Level 1 Screening Meeting Minutes

Project: US-20; Ashton to SH-87 JCT PEL

Subject: Screening

Date: January 20, 2022

SA4-C1

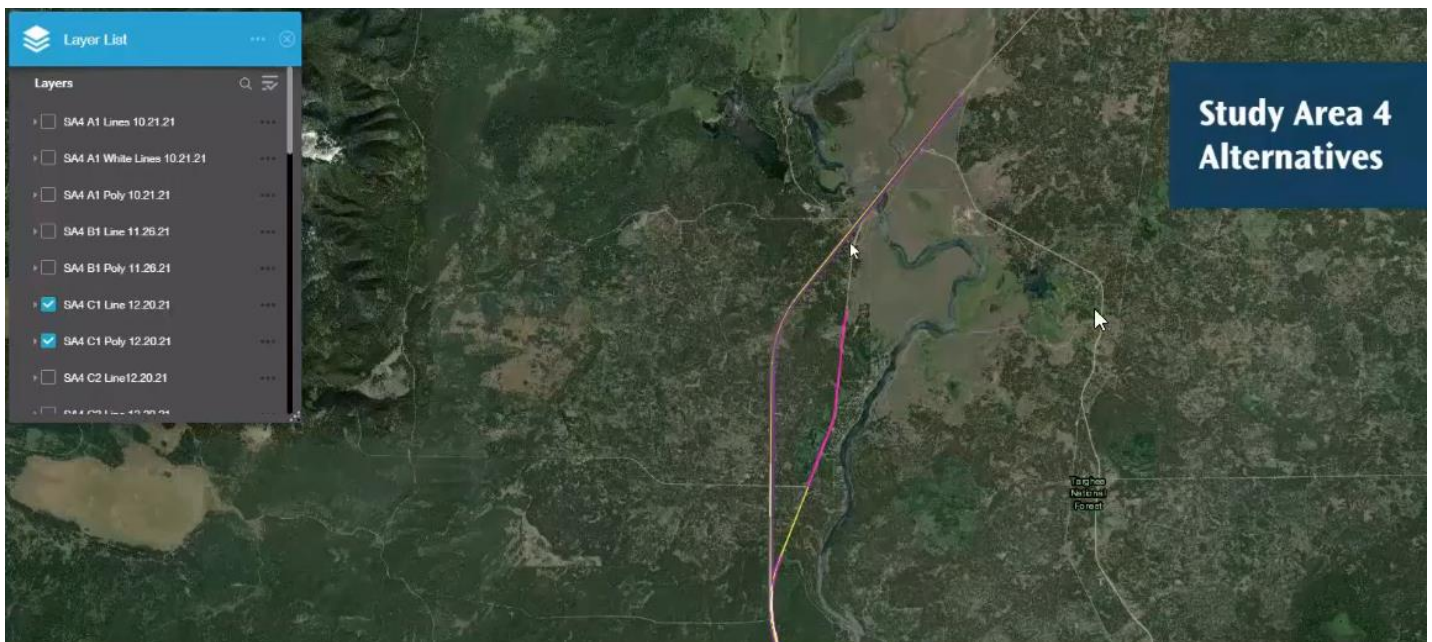
- Agency input is needed to further evaluate the alternative effectiveness
- Alignment of C2 may be a consideration for the alternative alignment

Results of discussion: SA4- C1 moves forward

SA4-C2

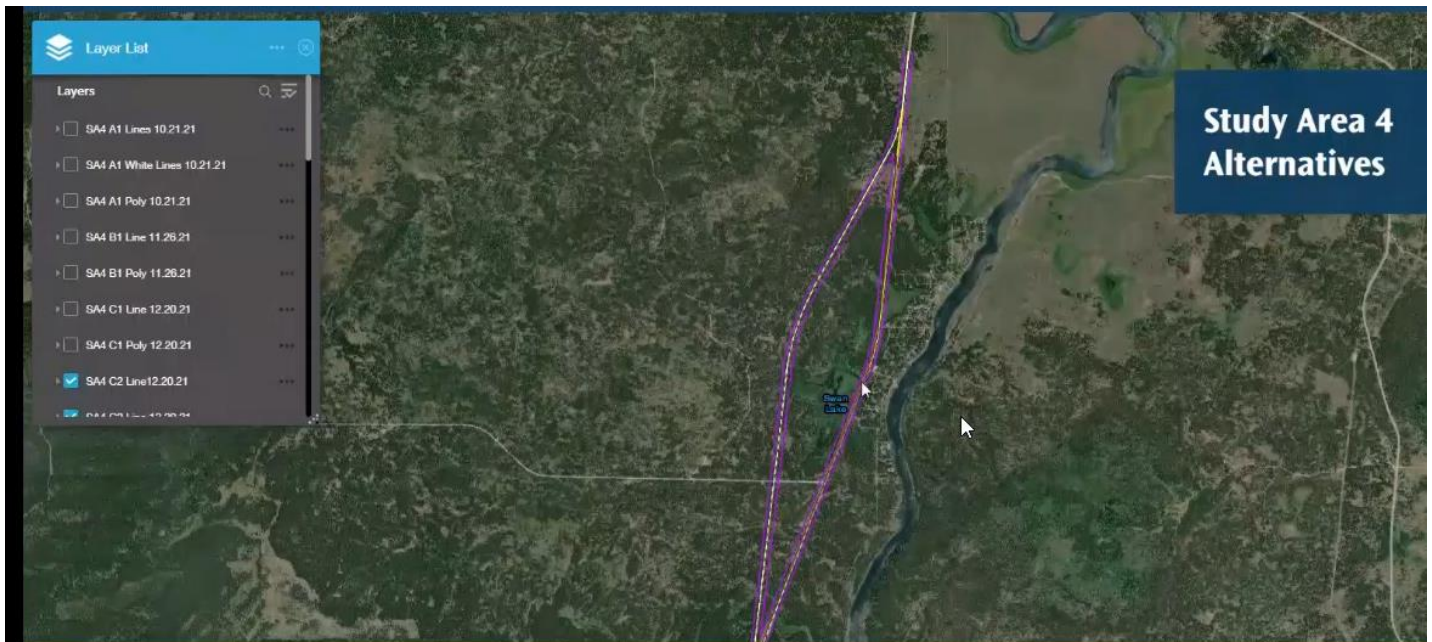
- Only provides for future southbound expansion.
- Emergency vehicles have issues with couplets when responding to accidents.
- Doesn't avoid environmental impacts
- Will need to provide local highway connections for both NB & SB

Results of discussion: SA4- C2 does not move forward (as it is written now as a couplet) Alignment for C2 may be conserved for alternative SA4-C1

SA6-C1

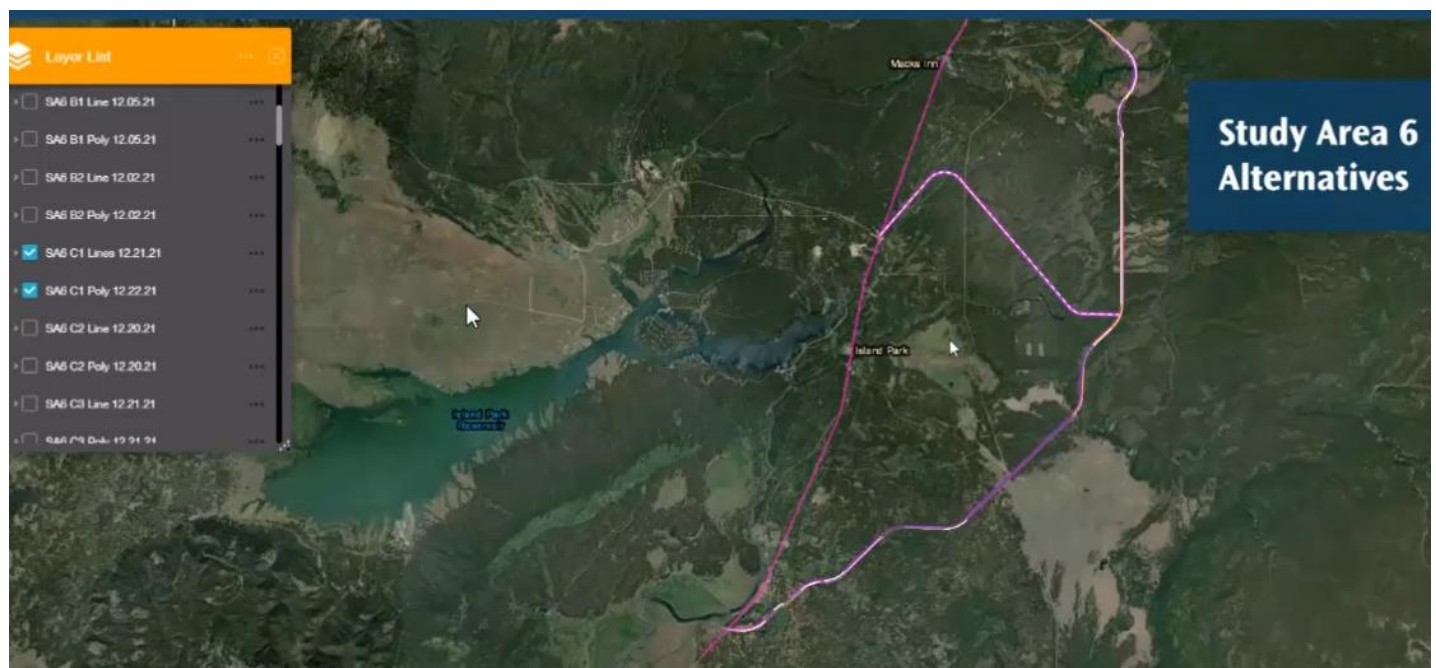
- Concerns with environmental Impacts
- Travel time increase
- Town cohesion
- Existing US-20 might be used for a short cut
- The most impactful off alignment design
- Meets P&N
- Safer
- From a general traffic standpoint, meets P&N with 2 lanes each direction

Results of discussion: SA6- C1 does not move forward

[SA6- C19](#)

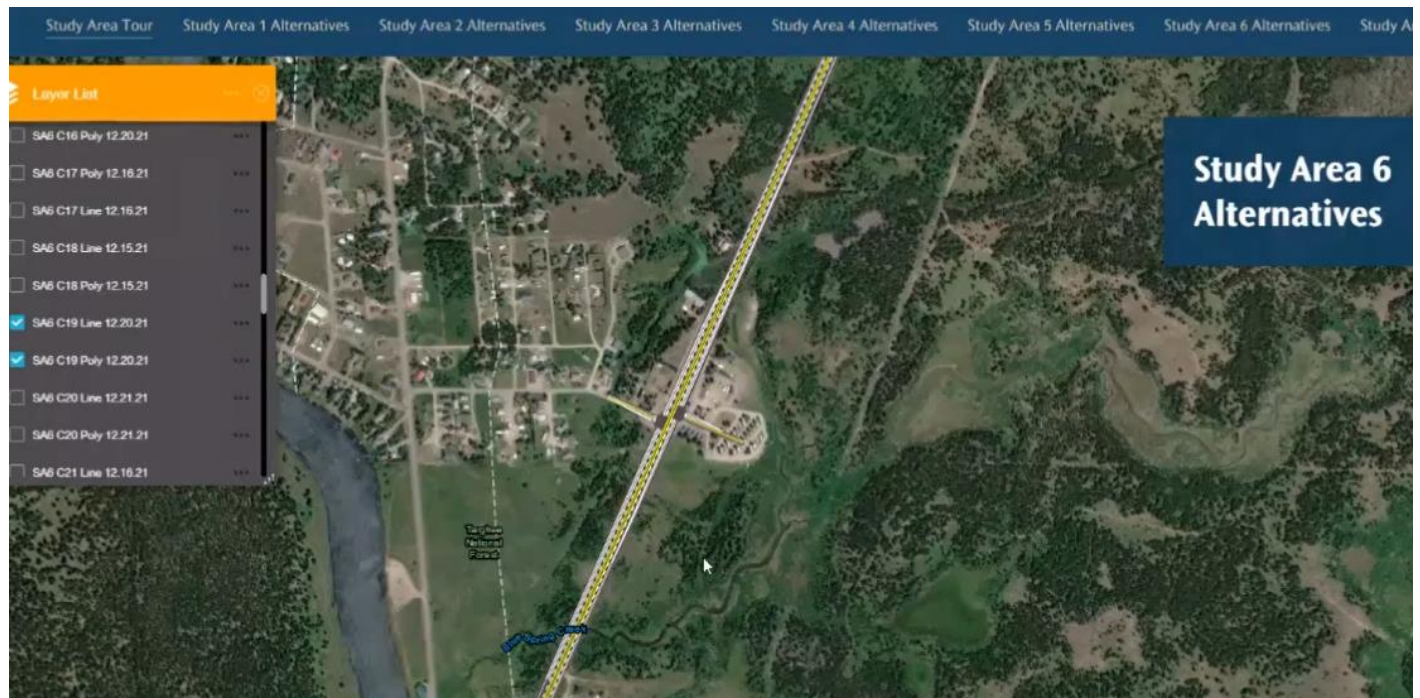
- Off set intersections are a safety concern.

SA6-C12

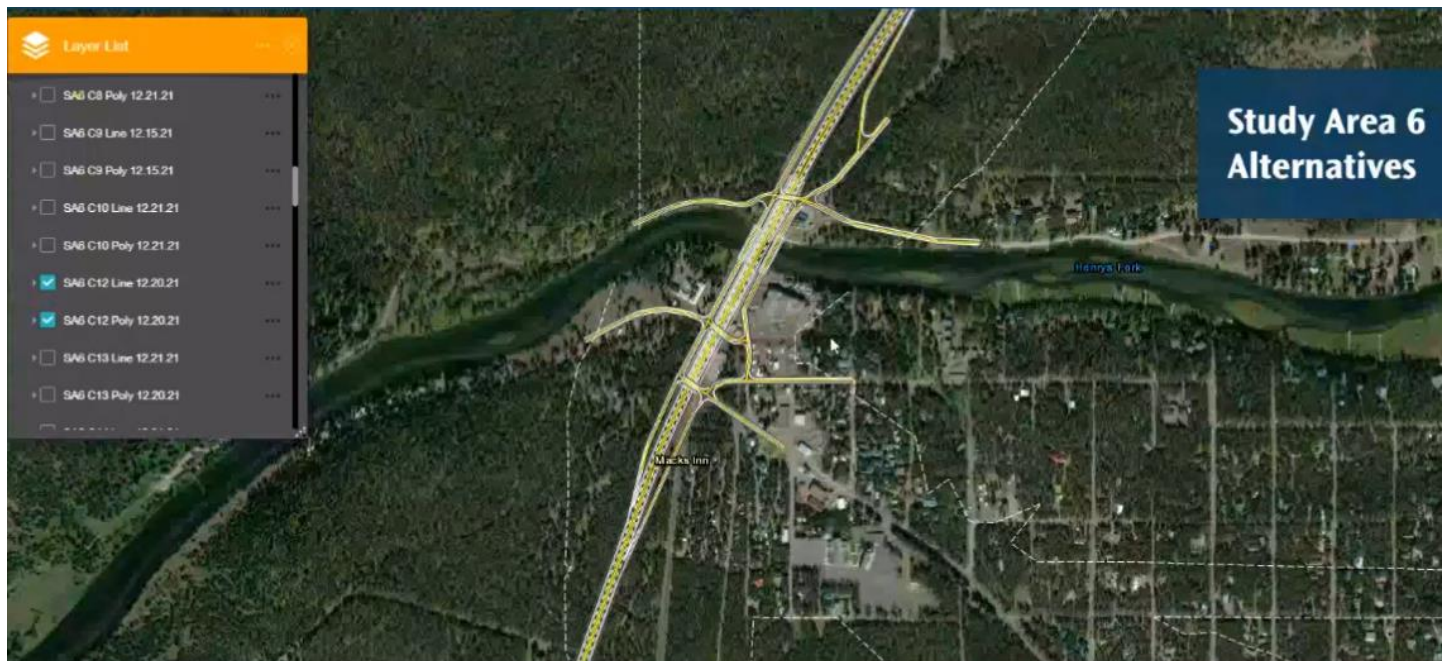
- It does meet the P&N criteria
- Effectively accommodates the traffic movements in the area.
- This will change the local aesthetic by virtue of its complexity (continue to evaluate this design along with less intrusive solutions that also meet the P&N)
- There may be significant impacts to resources for construction
